MEMORANDUM

Subject: Response Letter to Bruce White and Teresa Chilelli-White

Re: **Final Plat Approval Chatham Ridge Development, Kirkland, WA**
DDES File No. L08FR036
Ordinance 15716

Subject: Chatham Ridge Development, Kirkland, Washington

EXHIBIT 5

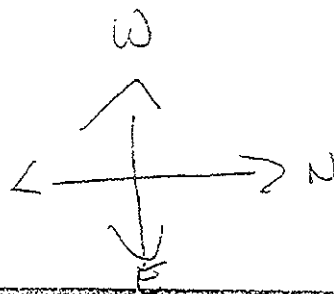
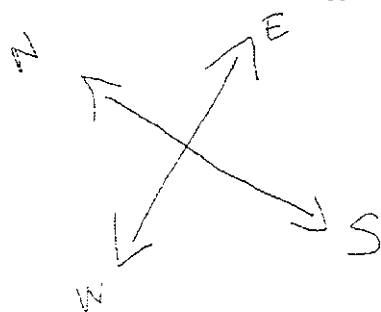
As the photos attached as Exhibit 5 and the map at Exhibit 6 illustrate, there has already been a vault failure at the SW corner of the vault, causing sheet flow onto the White property. Prior to the Chatham Ridge Development, flows went into a drainage swale. The photos also show the silt and gravel deposited on the White property by the water flows. Should the system fail on a larger scale, the resulting damage to the White property will be increased. DDES has taken the position that if the Whites are concerned about flooding, they have "the option of adding additional protections to satisfy her own concerns at her own expense." This is a misstatement of the law and of the policies in the KCSWDM meant to protect property from the injuries effects of stormwater flows from new development. In *Sigurdson v. City of Seattle*, 48 Wn.2d 155, 163, 292 P.2d 214 (1956), the court explained that a homeowner does not have a duty to "guard against and fend off" waters that have been artificially collected and discharged.

Vault Failure @
Sw corner of vault.

Vault
Failure at SW
Corner of Vault
Causing water
to Sheet Flow West
over Gravel Road
on our South
Property Border

water flowing Directly west
on our ROAD & Not into

Drainage Swale
on North Side
of ROAD

Silt & gravel
that settled on
our property after
flowing directly west
from the end of the new
Road.

In your letter, you state that the drainage facility within this development recently experienced a failure. The system was under construction at the time the pictures that you sent were taken. It has since been reviewed by the project's engineer and repaired. Since the approved drainage facilities have not been completed and accepted in the field, it is premature at this point to consider this incident to be an indication of failure in the final engineering design.
